## SOLICITATION AMENDMENT MODIFICATION DE L'INVITATION

<b>Title - Sujet</b> FIT-UP CONSTRUCTION - BRIDGEWATER	
<b>Solicitation No. - N° de l'invitation</b> EB144-150311/A	<b>Amendment No. - N° modif.</b> 005
<b>Client Reference No. - N° de référence du client</b> EB144-15-0311	<b>Date</b> 2014-07-03
<b>GETS Reference No. - N° de référence de SEAG</b> PW-\$PWA-122-5085	
<b>File No. - N° de dossier</b> PWA-4-72004 (122)	<b>CCC No./N° CCC - FMS No./N° VME</b>
<b>Solicitation Closes - L'invitation prend fin at - à 02:00 PM on - le 2014-07-10</b>	<b>Time Zone</b> Fuseau horaire Atlantic Daylight Saving Time ADT
<b>F.O.B. - F.A.B.</b> <b>Plant-Usine:</b> <input type="checkbox"/> <b>Destination:</b> <input checked="" type="checkbox"/> <b>Other-Autre:</b> <input type="checkbox"/>	
<b>Address Enquiries to: - Adresser toutes questions à:</b> Chinye (PWA), Chukwudi	<b>Buyer Id - Id de l'acheteur</b> pwa122
<b>Telephone No. - N° de téléphone</b> (902) 496-5476 ( )	<b>FAX No. - N° de FAX</b> (902) 496-5016

Amendment 005 is raised to answer the following questions and incorporate the changes below:

**Question 2:** Location: Outside Room 107

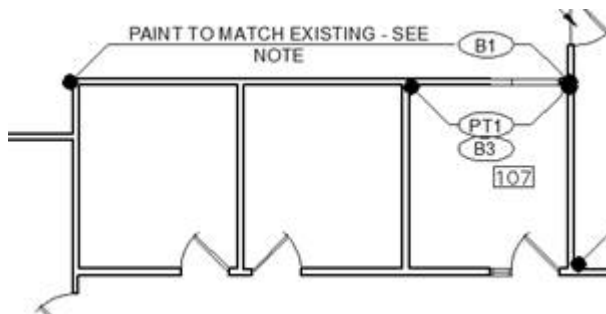
Existing textured paint is no longer available. Can an alternative be selected and will the entire wall be painted?

**Answer to question 2:** The entire wall to be painted as follows:

- Remove existing 4" section of chair rail and wall vinyl (below chair rail) located between the door frame and adjacent partition. Repair gypsum board and make ready to receive new paint finish.
- Prepare and make smooth existing partition, currently painted with spray applied textured paint, and make ready to receive new paint finish.
- Paint partition to match background colour of existing paint (cream).
